Request for Proposals #2018-002P – Building Cleaning Services for the Department of Parks

### Addendum #1

**GOVERNMENT OF BERMUDA** Ministry of Public Works

# PROPOSED PARKS DEPARTMENT HEADQUARTERS 169 SOUTH ROAD, PAGET PARISH, DV04

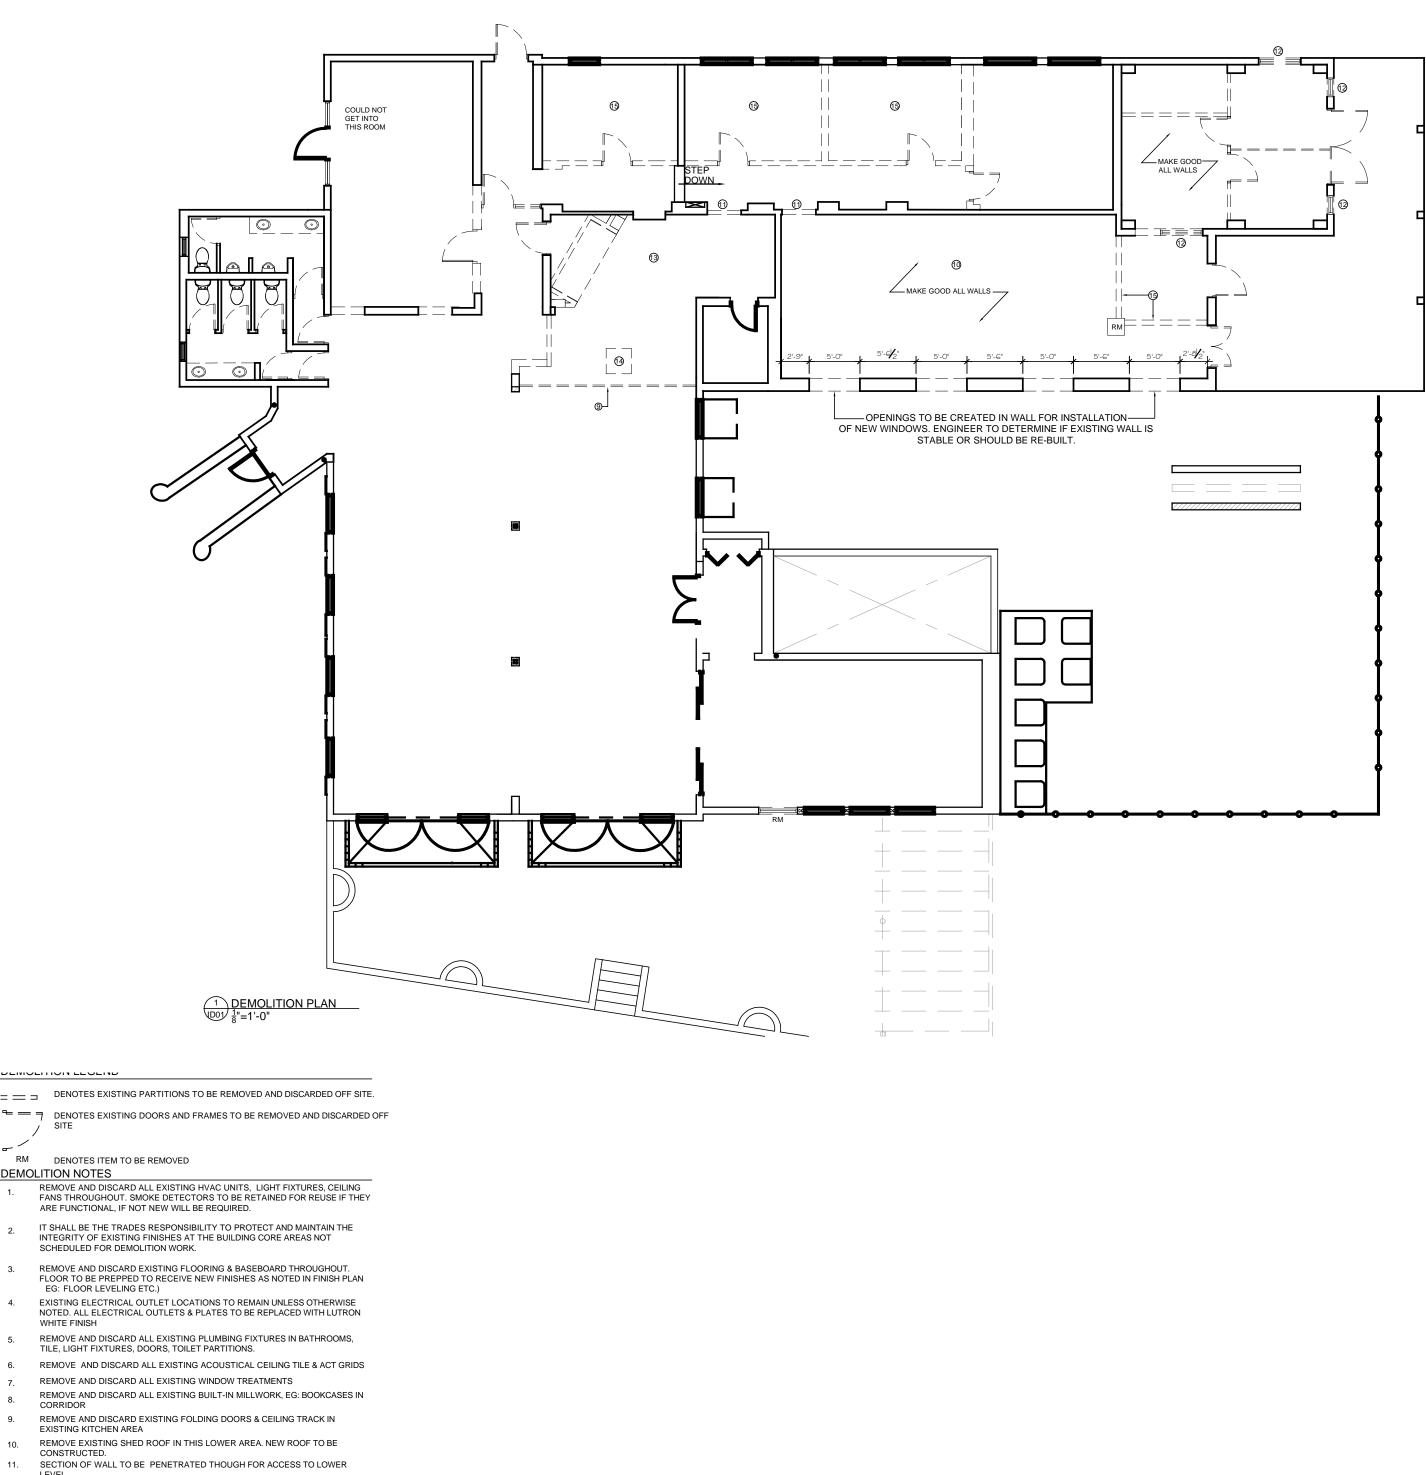
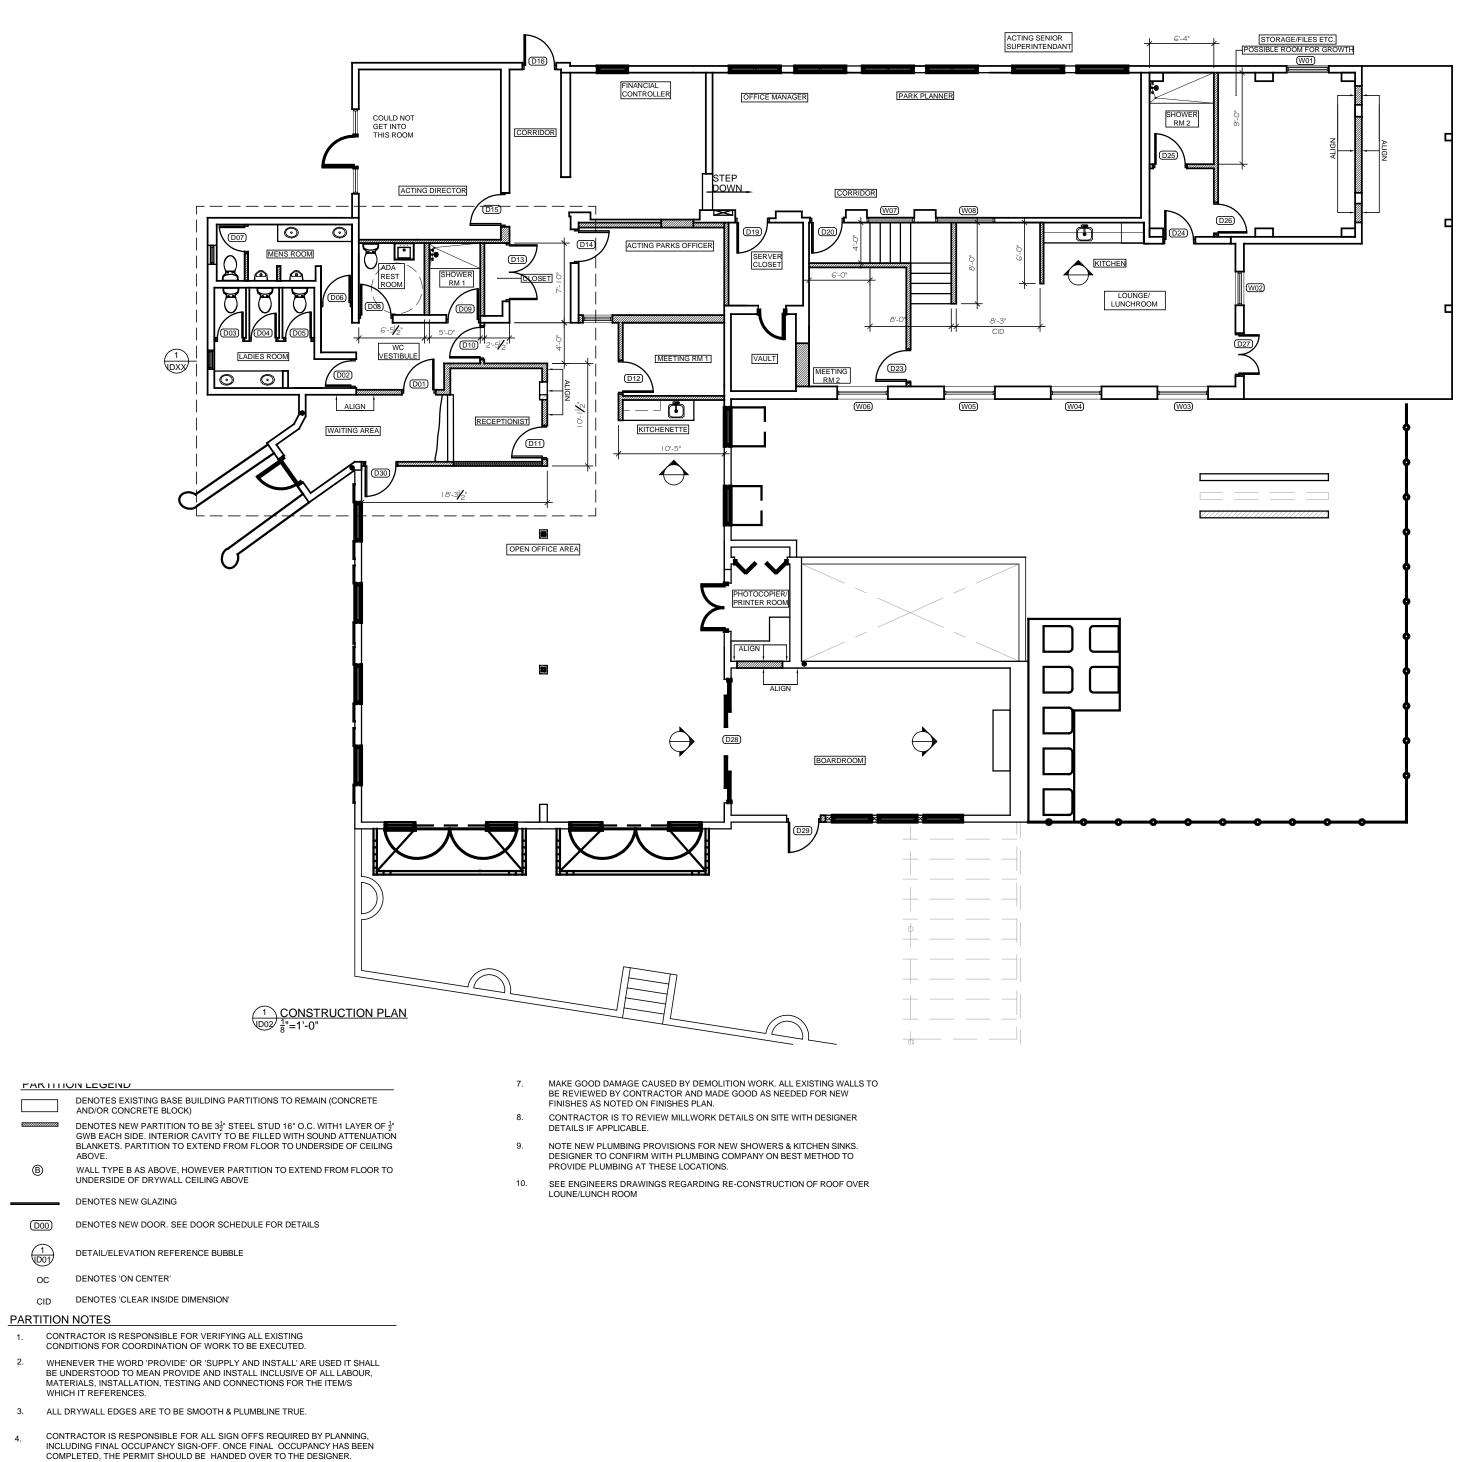
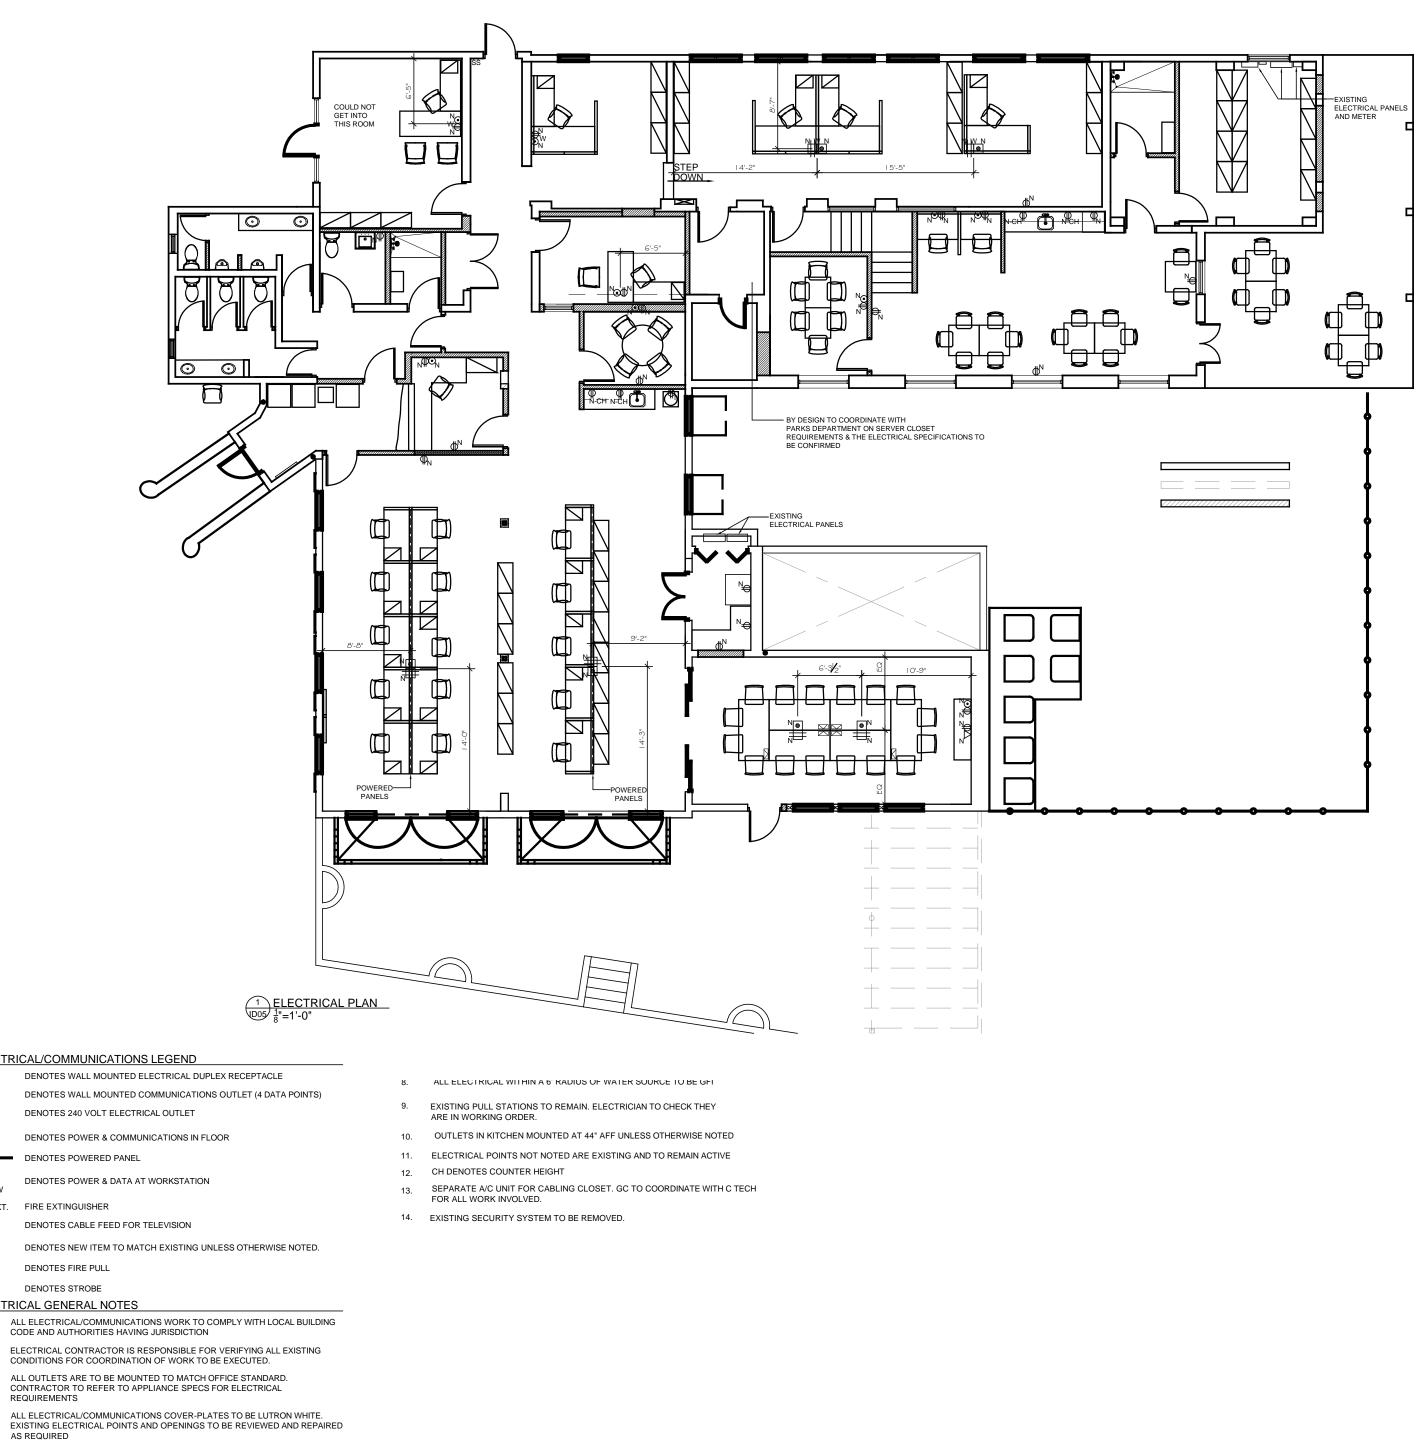
With renovations commencing at the Visitors Center in mid-April for 7-8 months thereafter, do you have information for what can be expected for this site?

The Government confirms the whole building will be renovated, not just the washrooms. Attached to this Addendum are floor plans to demonstrate the size and layout of the proposed areas under this contract.
